This note addresses the issues raised by comment #308 in Draft 1.1. The issue deals with the error detection properties of crc-32 when the bit transmission order within a byte is different from the ordering of bits used in crc-32 calculation. The three specific issues addressed are:

### Illustration of Problem Statement

**Figure 1. Rearrangement of Burst Error Bits Due to Bit Reversal within Bytes**

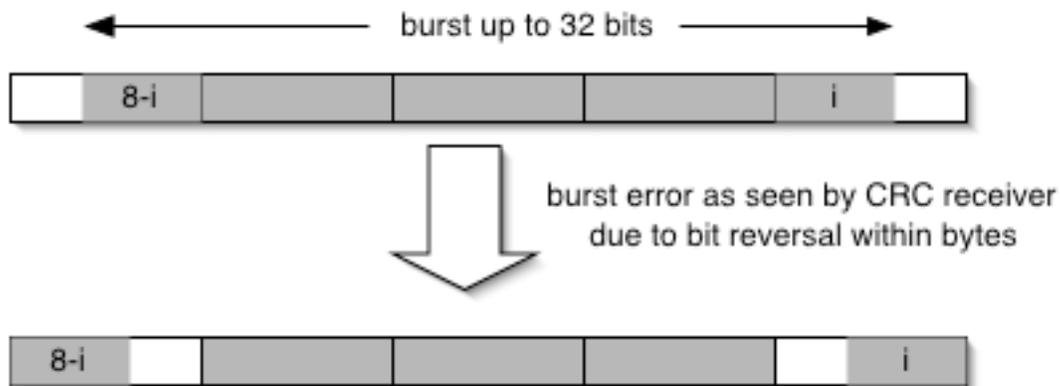
For comparative analysis we need only analyze burst errors up to length 32 in the transmission media. Because of bit reversal within bytes, burst errors of length up to 32 in the transmission media may not appear as of same length to the CRC calculation logic at the receiver. Figure 1. illustrates this.

There are eight different cases of interest. If the burst error in the transmission media is byte aligned (i.e,  $i=0$ ) then at the receiver side the crc-32 polynomial will also see it as a burst error of length 32. So for  $i=0$ , all byte aligned 32-bit burst errors are detected. The other

We can do an exhaustive simulation to determine if all of some of these misaligned ( $i=1, \dots, 7$ ) burst errors are detected by the crc-32 polynomial. My estimate is that this simulation will take several days as we have to do iterations of order  $7 \times 2^{32}$ .

For now, we can provide an upper bound on the probability of error detection. The upper bound is based on simple principle of decomposition and linear super-position.

Assuming all alignements of burst errors are equally likely then the probability of undetected burst is less tha or equal to  $1/8 \times (1/2^{31} + \dots + 1/2^{25}) \sim 2^{-27}$

Therefore the worst case upper bound on undetected burst error is 1 in  $2^{27}$ . The actual probability may be much less than this (determined through simulations). If the working group is interested then I can start the exhaustive simulation.

However, I strongly feel that even this upper bound value is small enough to warrant any change in the PHY reconciliation layer to do bit reversal. This will have an impact on implementation using exisiting Sonet framers.
